# Rezoning Transportation Analysis

Petition Number: 2018-076

Date	Description
07-13-18	First Review

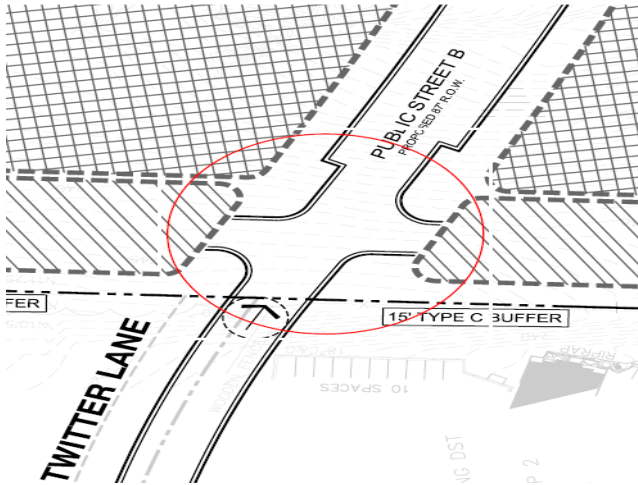
6. The petitioner should update site plan to better realign driveways across from each other as seen below.
